<Addendum>

PROJECT #: PA-0026-C01

DESCRIPTION: Interior renovations to existing medical office building for conversion to Kindergarten Center

Addendum No. 1

C-100 SITE PLAN

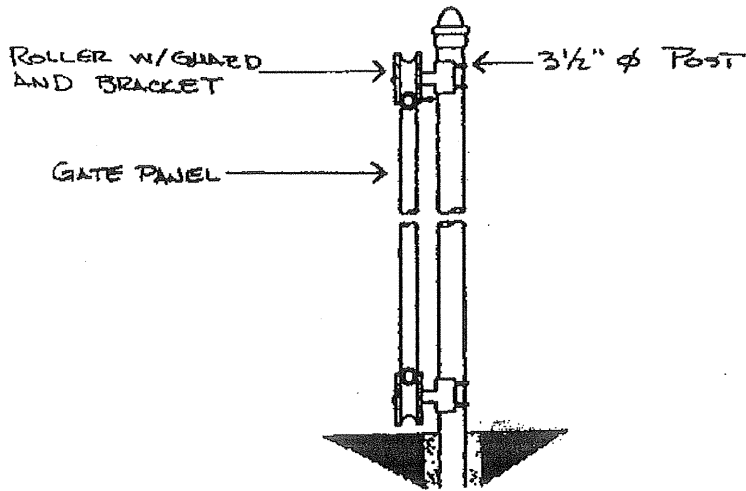
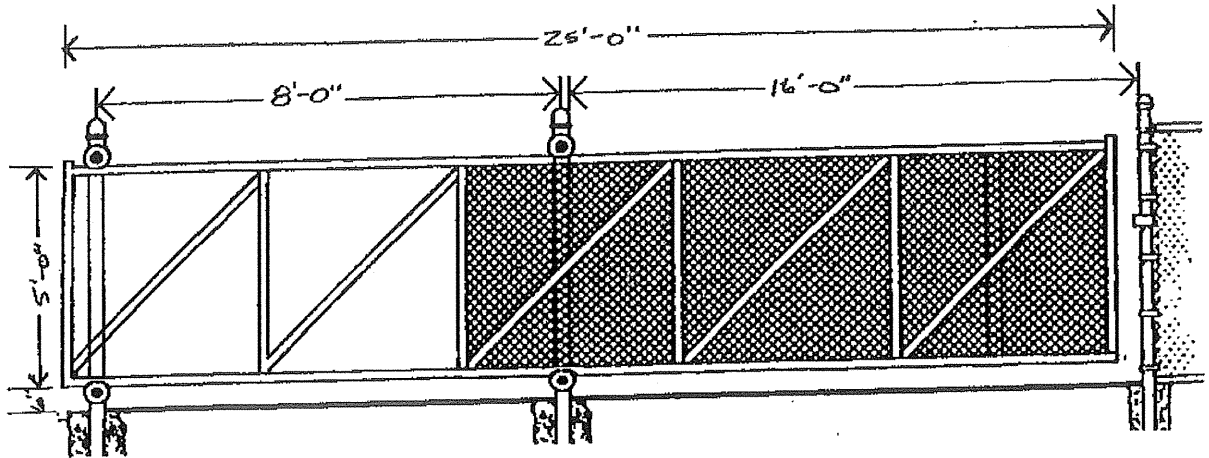
All known bidders are hereby advised the attached revised Addendum Attachment #1 to amend project drawing sheet No. C-100 as follows:

1. All references to fencing shall be new chain link fencing as specified in Section 02821 and shall be 8 ft. in height above grade typical.
2. At existing 30" high masonry wall (south end of parking lot) fence posts shall be core-drilled into existing masonry wall (minimum of 18" depth) with solid grouting typical.

3. Two (2) specified sliding gates (16' Ft.), Addendum Attachment #1, Page 1, shall be provided and installed as per Addendum Attachment #1, Page 2 and Specification Section 02821 – Chain-Link Fences and Gates.

4. Paving shall be provided and installed in parking areas as indicated per Addendum Attachment #1, Page 2.
5. Playground Equipment to be located and placed in area adjacent to building as indicated per Addendum Attachment #1, Page 2. (Approximate size: 21'x96.5')

6. Playground Safety Surfacing to be located and placed in area adjacent to building as indicated per Addendum Attachment #1, Page 2. (Approximate size: 21'x96.5')

ROOF HATCH LADDER DETAIL
ADDENDUM ATTACHMENT 3

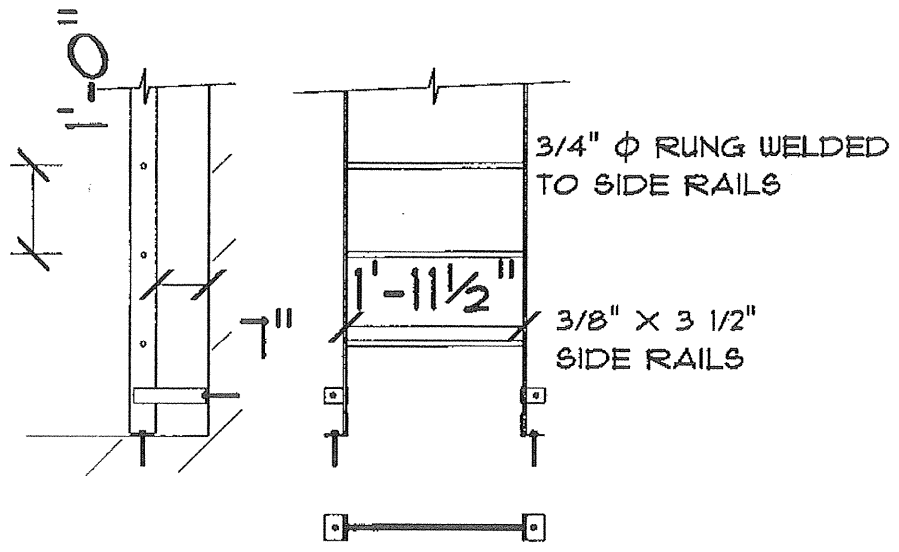
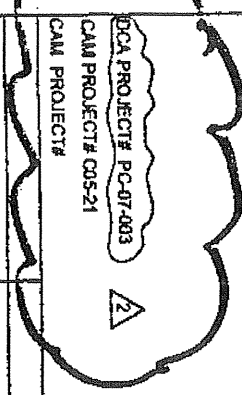
All known bidders are hereby advised that a Metal Roof Ladder shall be installed in Room 104A for roof hatch access. See Addendum Attachment #3

ADDENDUM ATTACHMENT #4

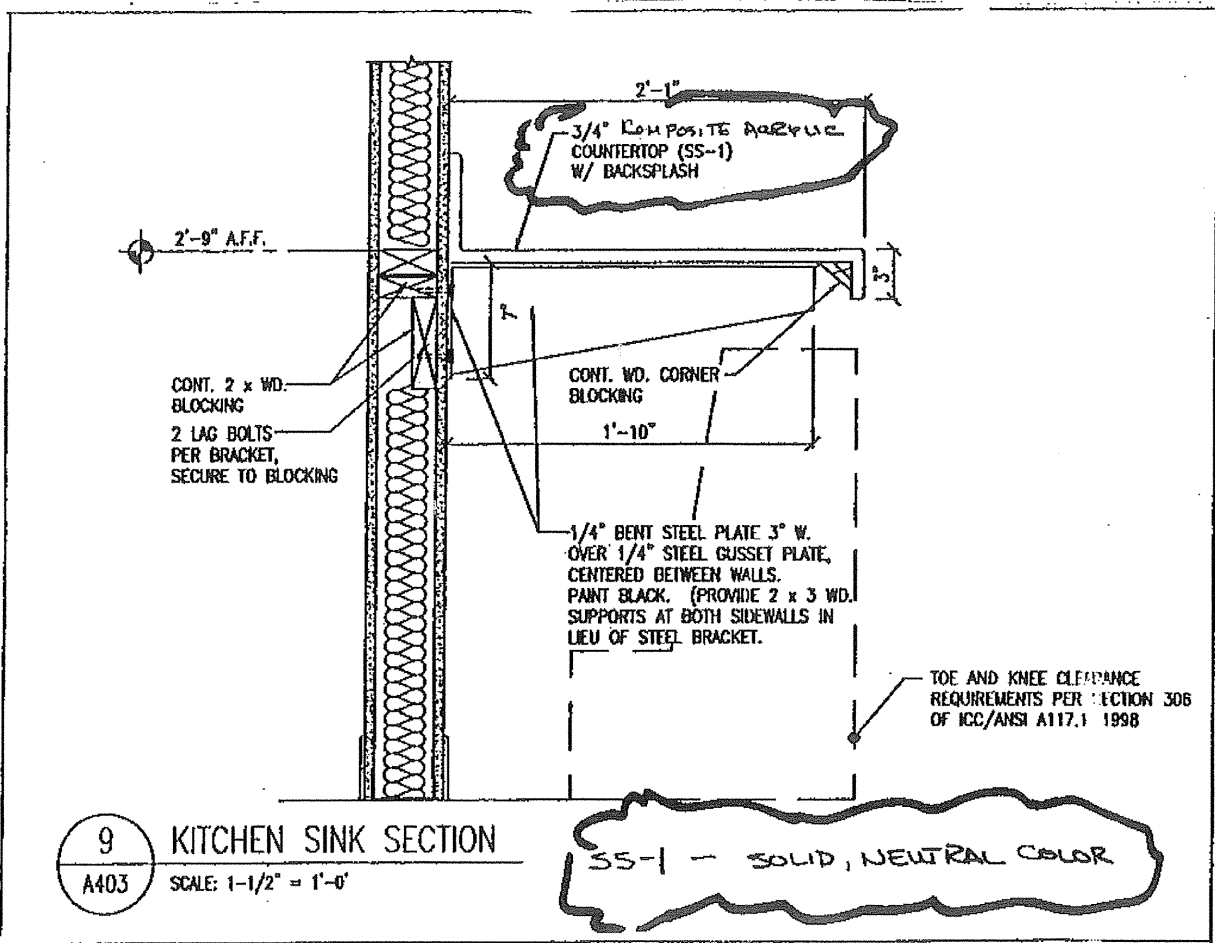
All known bidders are hereby advised to see Addendum Attachment #4 “Countertop / Sink @ Room 114”.

DETAIL OF ROOF DRAIN AND OVERFLOW DRAIN

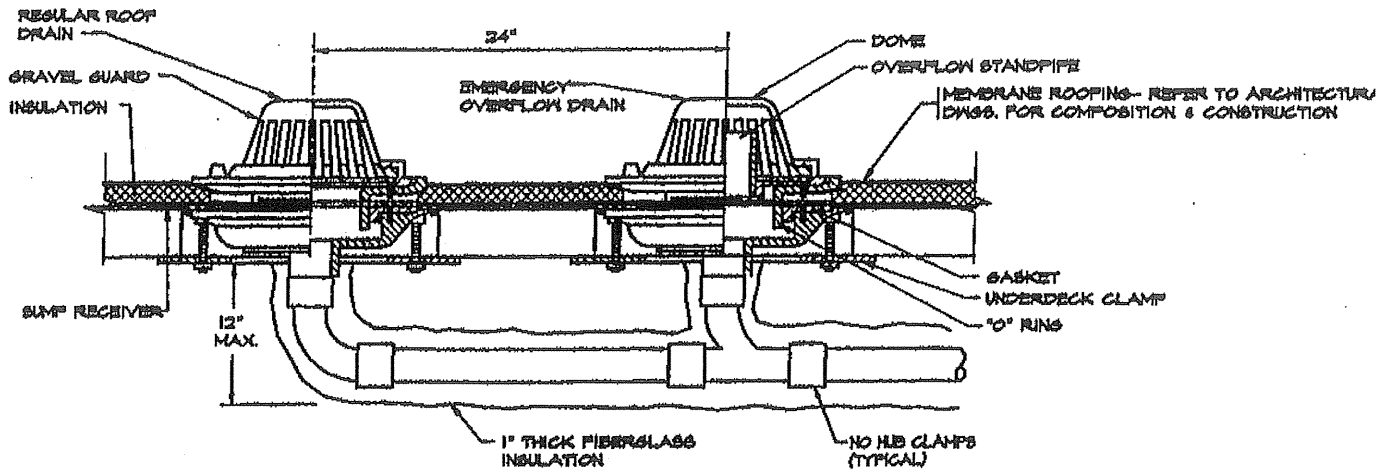
- A. Provide fully adhered 24” x 24” rubber roof walkway pads, continuous path from roof hatch to each rooftop unit.
- B. Additional exhaust fan location, not shown on A-102, near east parapet for exhaust fan EF-11 as shown on H-100 at Mechanical Room 109A.
- C. For bidding purposes, provide a minimum of two (2) built-up roof crickets at each new rooftop unit as called out on A-102.
- D. See detail for overflow roof drain on Addendum Attachment #5.
